Interactive comment on “Effects of nitrate and phosphate supply on chromophoric and fluorescent dissolved organic matter in the Eastern Tropical North Atlantic: a mesocosm study” by A. N. Loginova et al.

Autor comments to : Interactive comment by A. N. Loginova, C. Borchard, J. Meyer, H. Hauss, R. Kiko, and A. Engel entitled “Effects of nitrate and phosphate supply on chromophoric and fluorescent dissolved organic matter in the Eastern Tropical North Atlantic: a mesocosm study.” submitted to Biogeosciences and coded bg-2015-181.

Fig. 1.

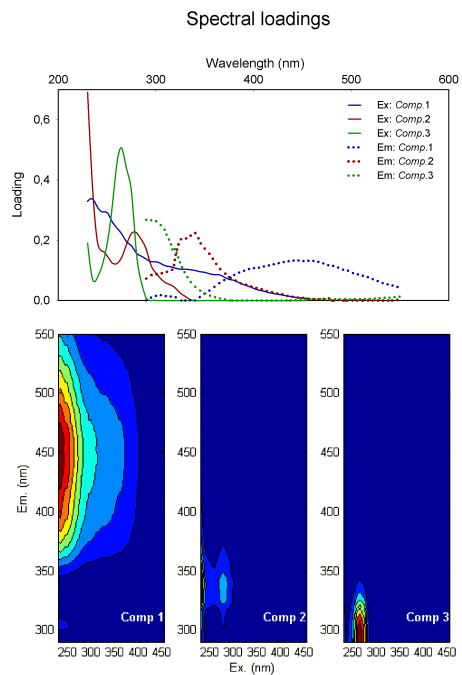
7. Authors did not show the three fluorescent components as an EEM Figure that should be needed to show in the manuscript. AC: The figures in the current manuscript are rather numerous, therefore it was decided that the figure with the fingerprints and spectral loadings of modelled components goes to the attachments of the manuscript. However, we understand the importance of including it to the text body and will include the figure now.
